**GENOA CHARTER TOWNSHIP
PLANNING COMMISSION
PUBLIC HEARING
JULY 10, 2023
6:30 P.M.
AGENDA**

OPEN PUBLIC HEARING #2... Consideration of a rezoning application, amendment to the Latson Road PUD Agreement, Environmental Impact Assessment and conceptual PUD Plan for a proposed rezoning and conceptual plan approval to expand the existing Planned Unit Development. The rezoning request is from Country Estates (CE) to Interchange Campus Planned Unit Development (CAPUD) and Interchange Commercial Planned Unit Development (ICPUD) for approximately 138 acres of undevelopment land. The request involves parcel 4711-09-300-046 which is located at the southeast intersection of Latson Road and Beck Road. The remaining parcels are located south of Crooked Lake Road and west of Latson Road consisting of the following parcel ID#s: 4711-17-200-006, 4711-17-200-002, 4711-17-400-015, 4711-17-400-013, and 4711-17-400-014. The request is petitioned by Todd Wyatt.

Attention:	Amy Ruthig, Planning Director
Subject:	Versa Development/Innovation Interchange – PUD Expansion (Review #2)
Location:	Latson Road, between Crooked Lake Road and I-96 (approximately 138 acres)
Zoning:	CE Country Estate

**Re: Latson

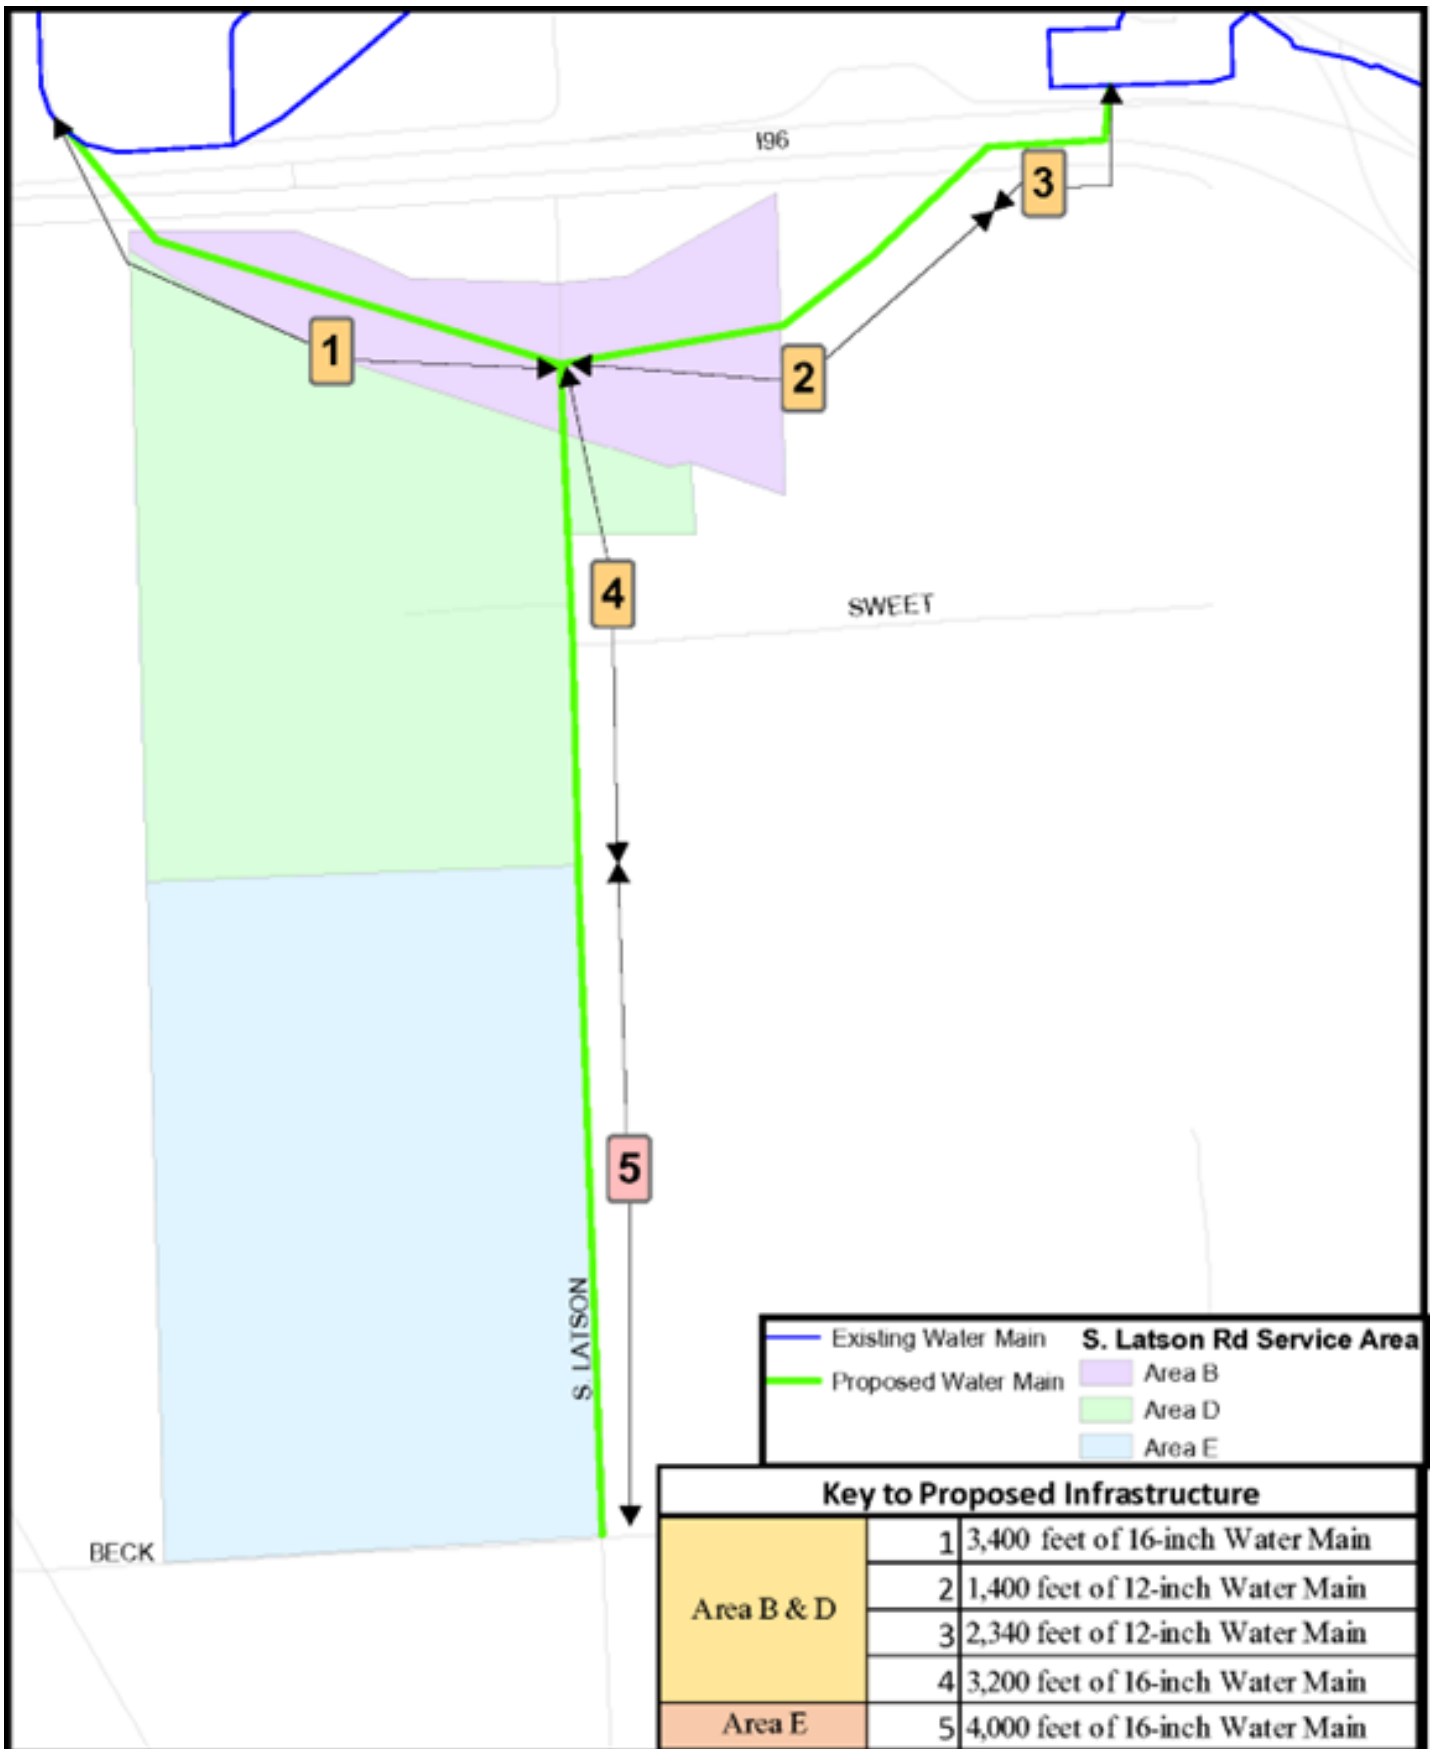
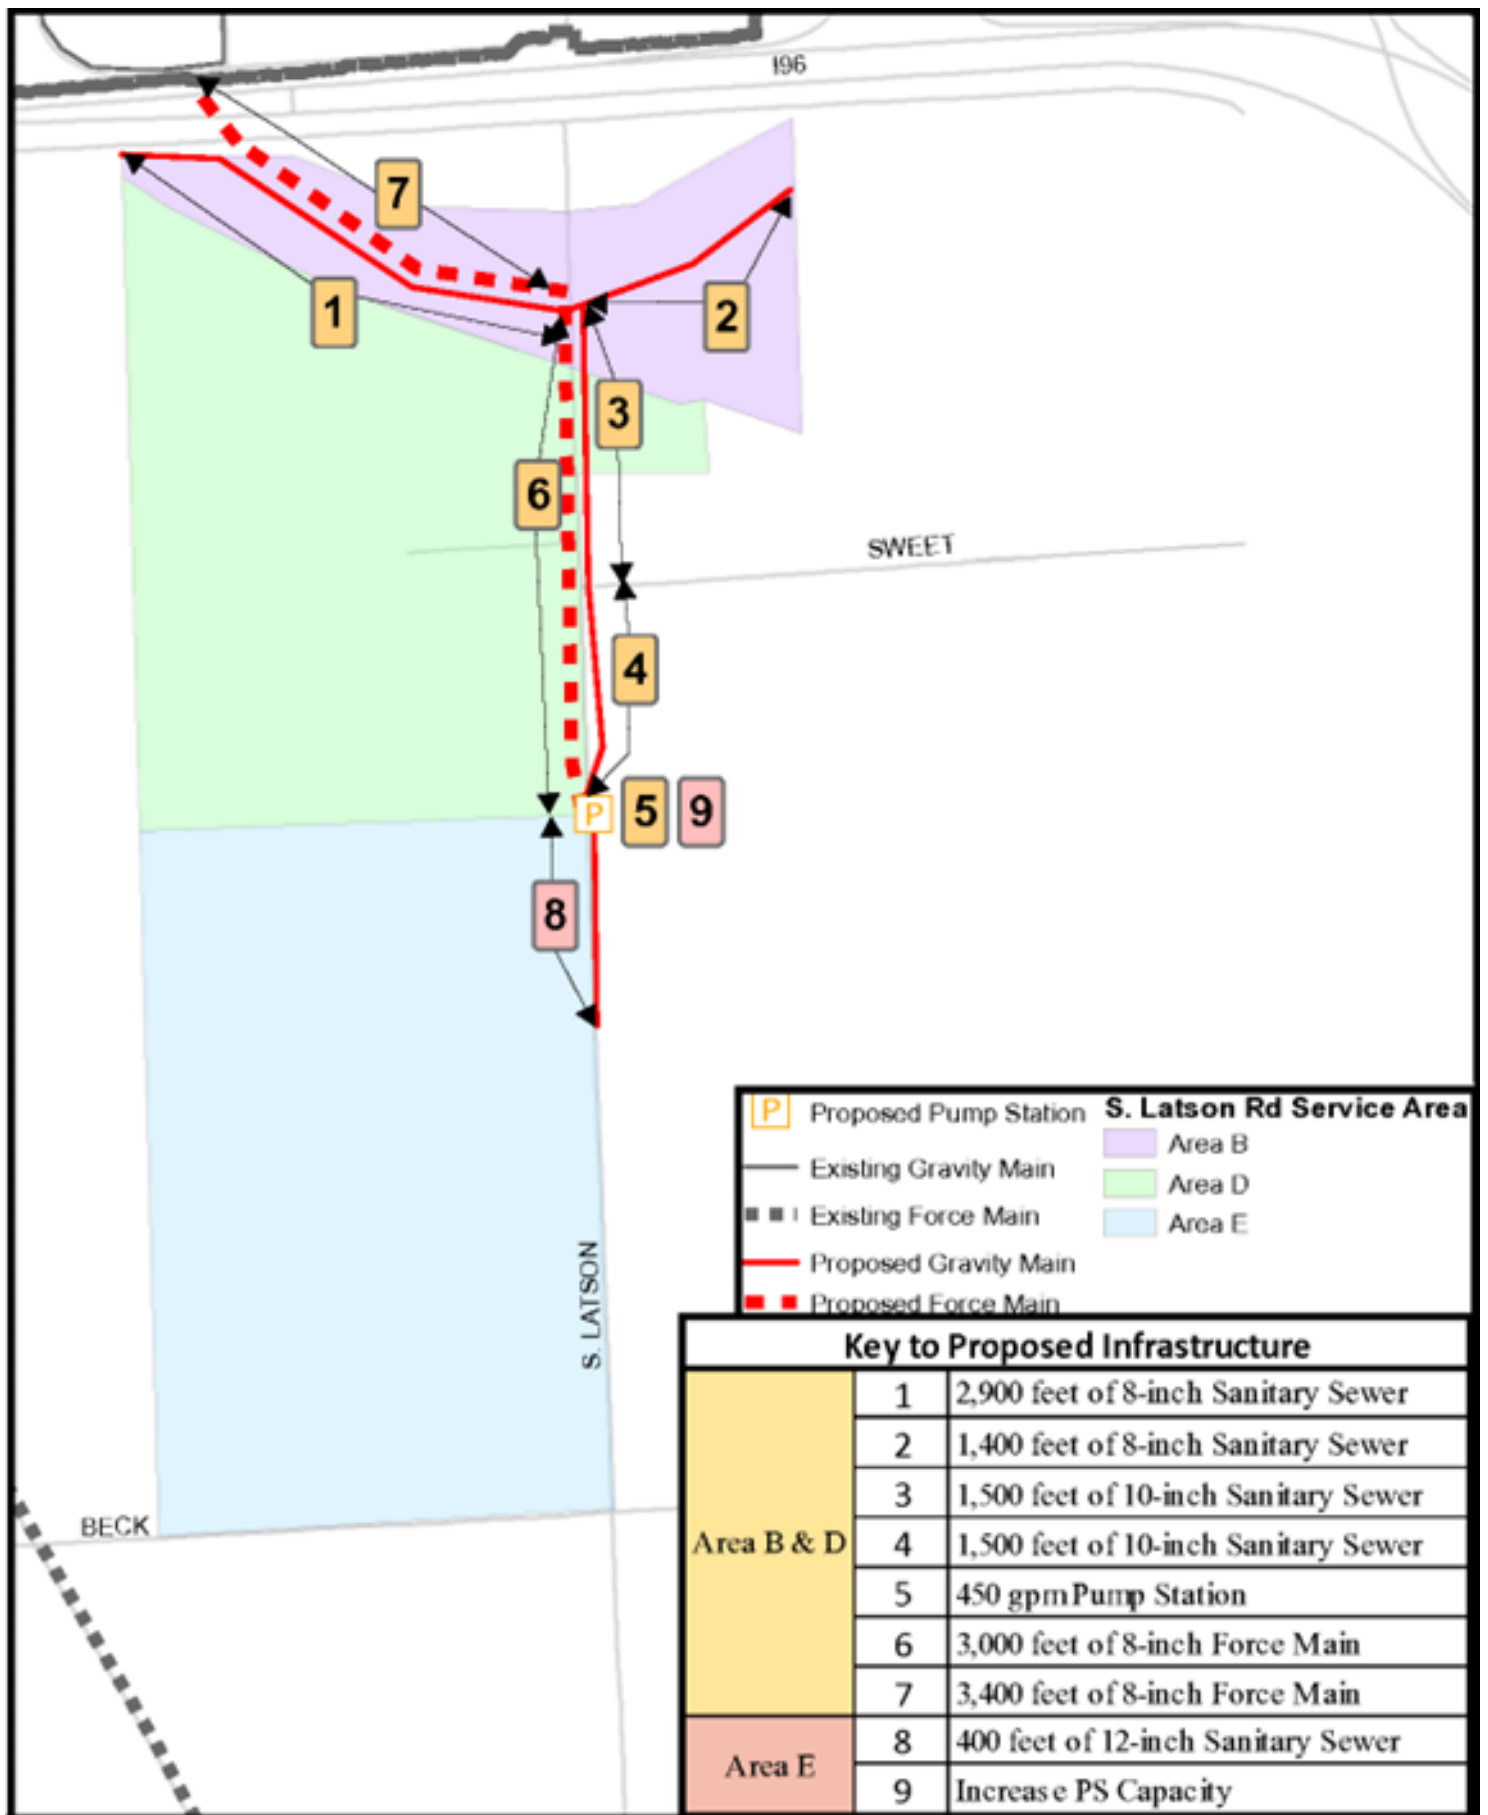
3. Figures 2 and 3 in the impact assessment are outdated and no longer show existing infrastructure accurately. Some of the water main and force main shown as proposed is now existing. These figures also don't match with the latest concepts that the Township has, which have been attached separately for reference. The impact assessment and concept plans should provide more detail on how the proposed expansion area will be served with water and sanitary sewer service, including updated concepts or alternatives on how water and sewer would be routed to the entire PUD area.

Preliminary Concepts

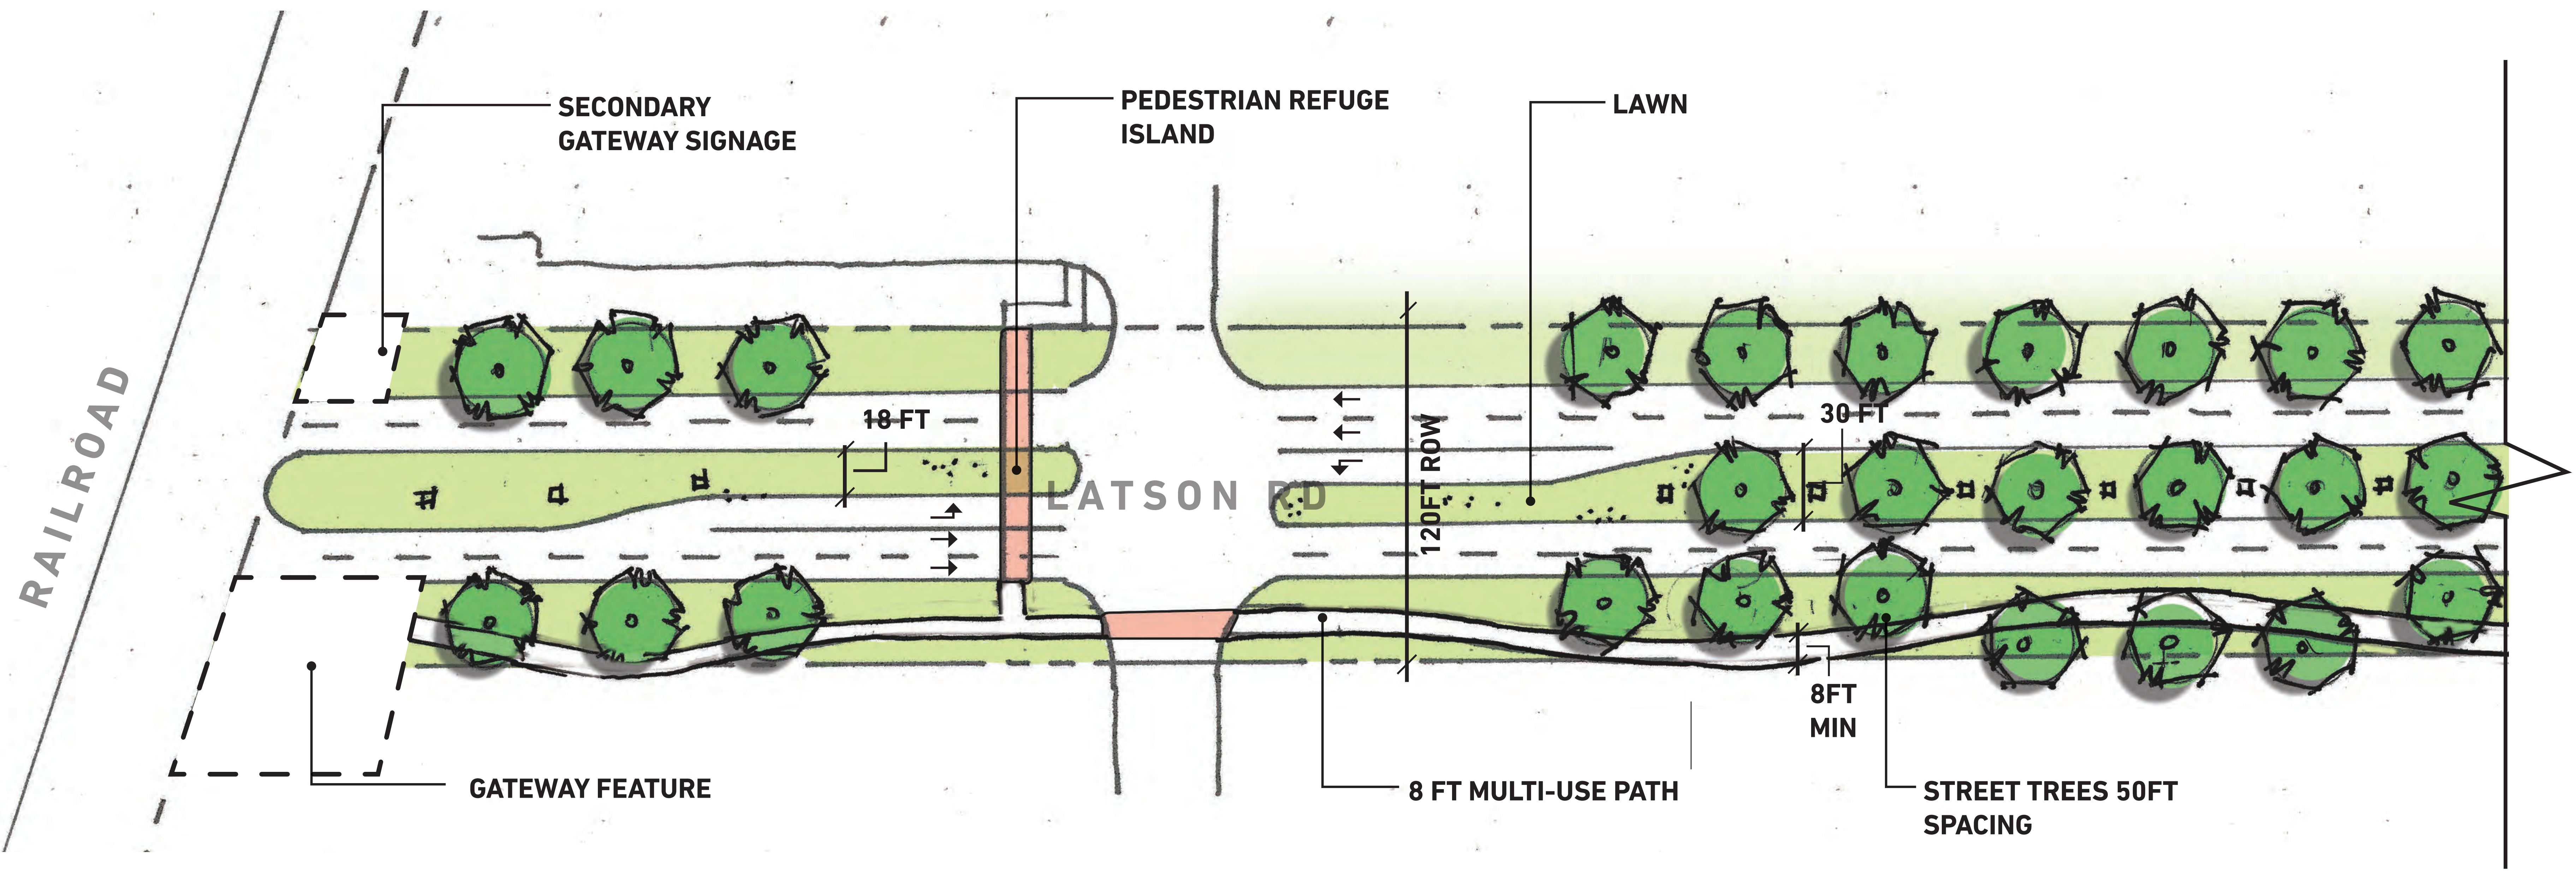
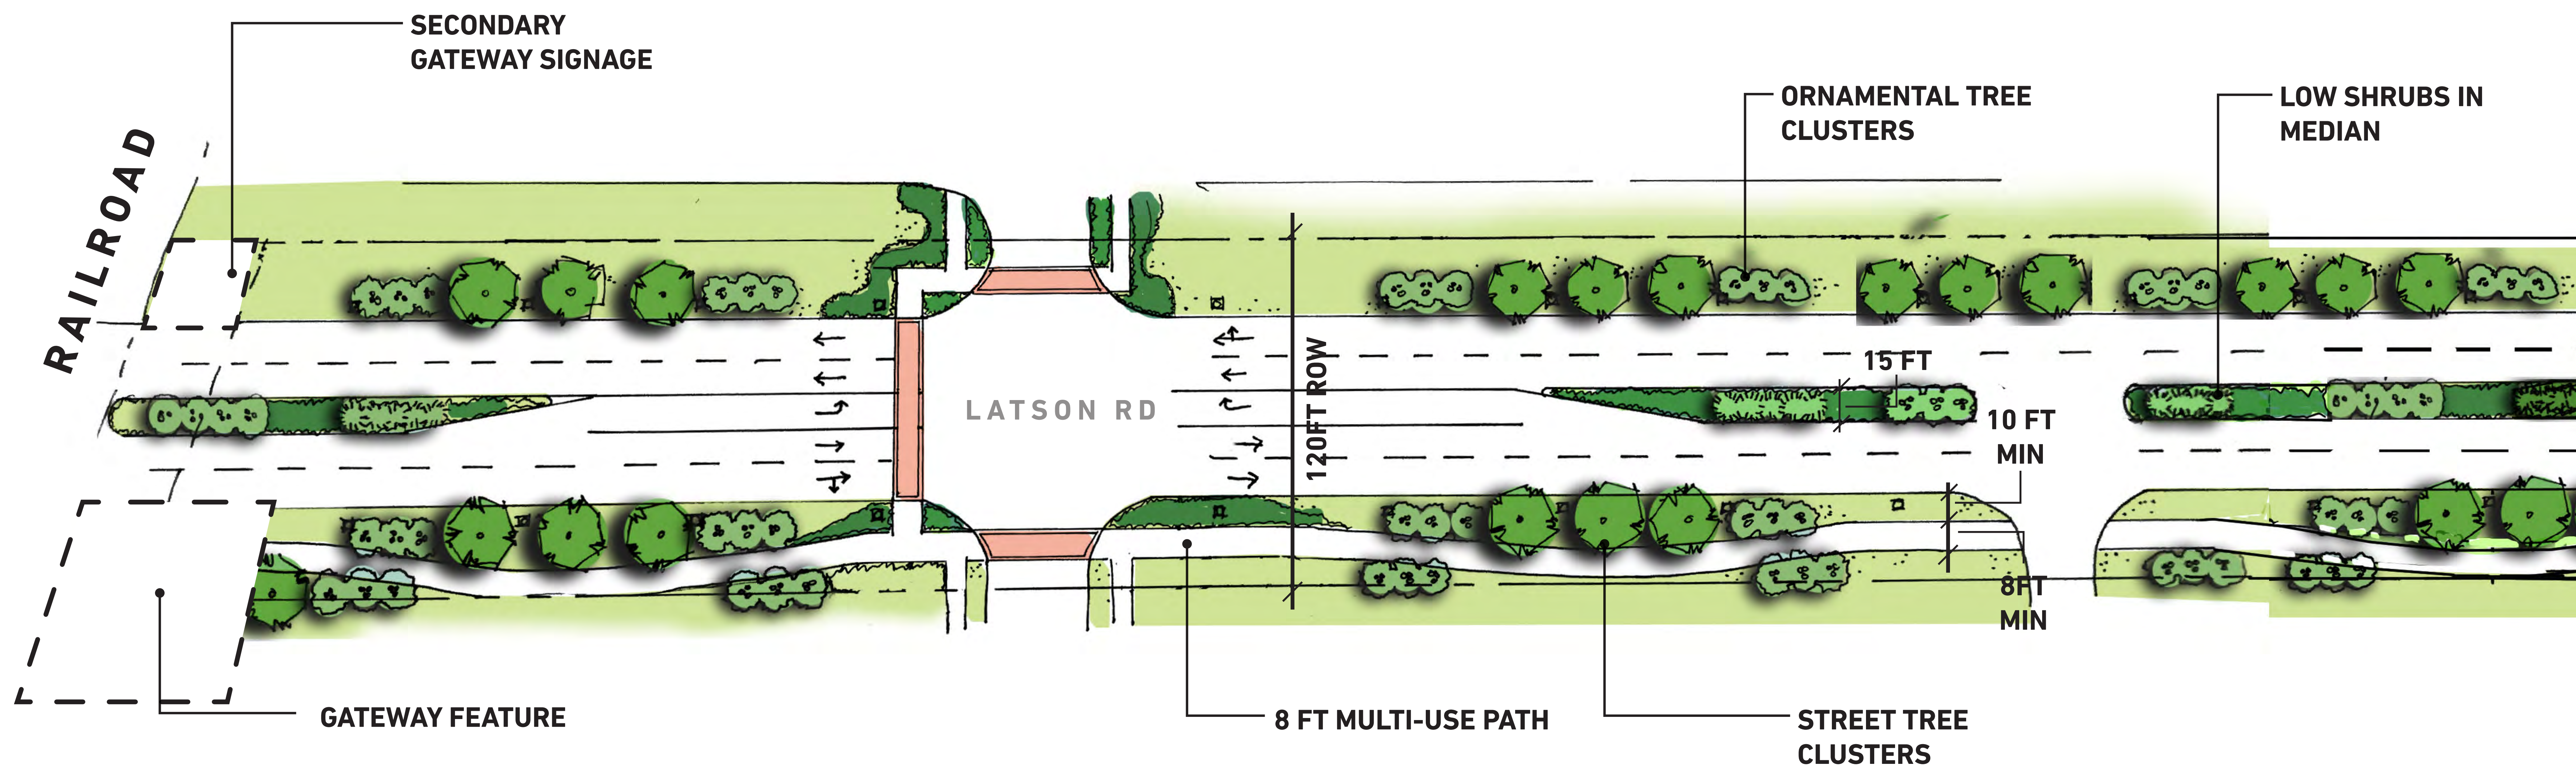
4. The Innovation Interchange preliminary Latson Road concepts show one of the site driveways lined up directly with Sweet Road. The property directly to the west of Sweet Road is not within the proposed PUD area, so lining up the intersection will not be possible as shown.

TOWNHOME :
REAR-LOADED WITH SURFACE PARKING

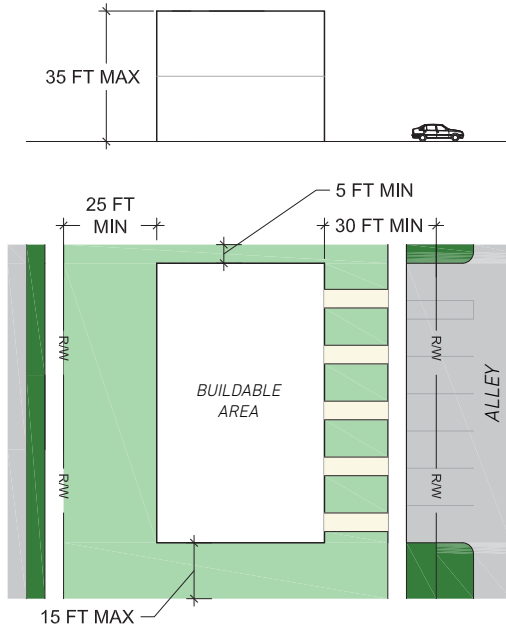
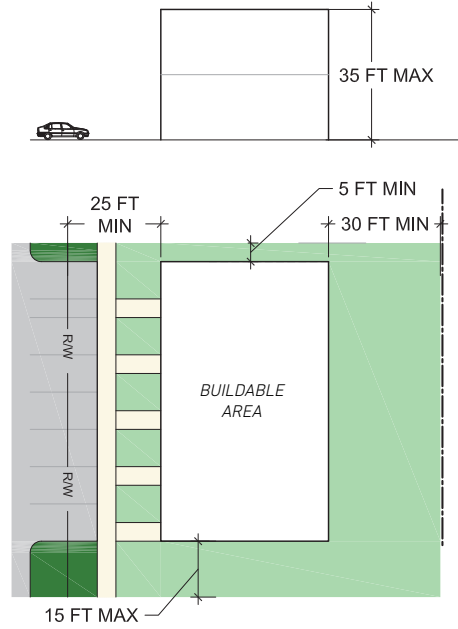
Add something to prevent repetitive design copy cat type housing developments.

FOURPLEX STACKED :
REAR-LOADED WITH SURFACE PARKING

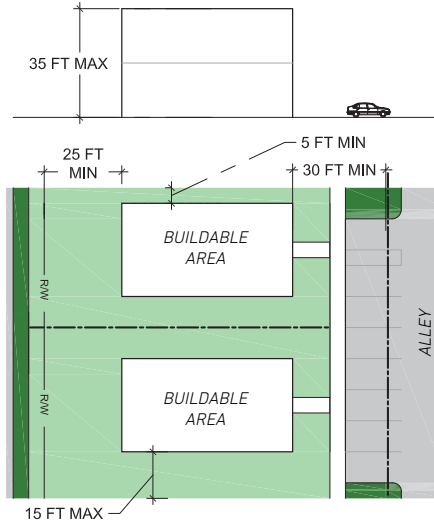
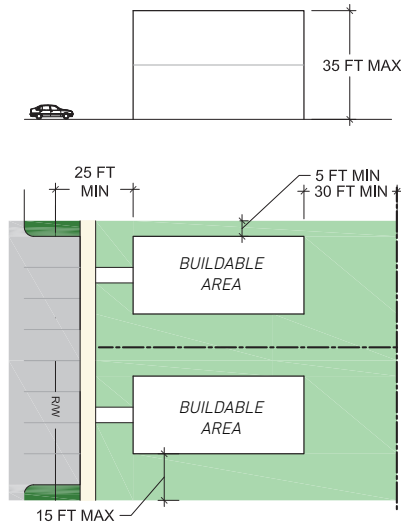
These images don't match

Design guidelines require brick. Do you have examples of brick fourplex units?

APARTMENTS :
REAR-LOADED WITH SURFACE PARKING

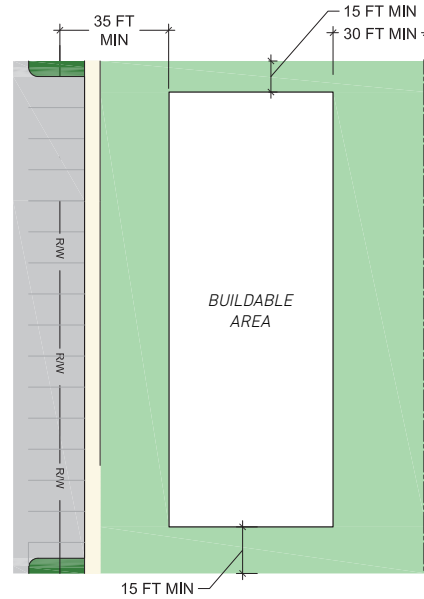
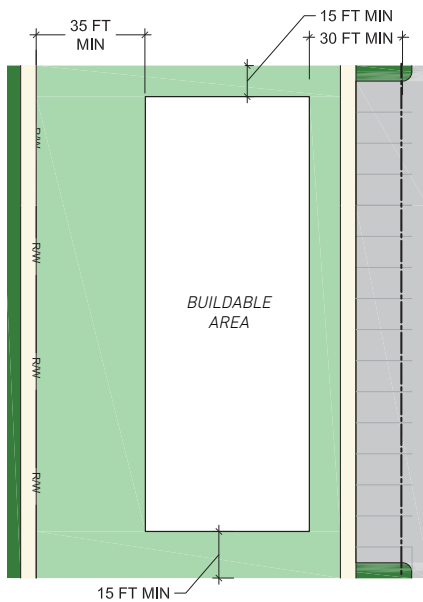
Design guidelines require brick. Do you have examples of brick fourplex units?
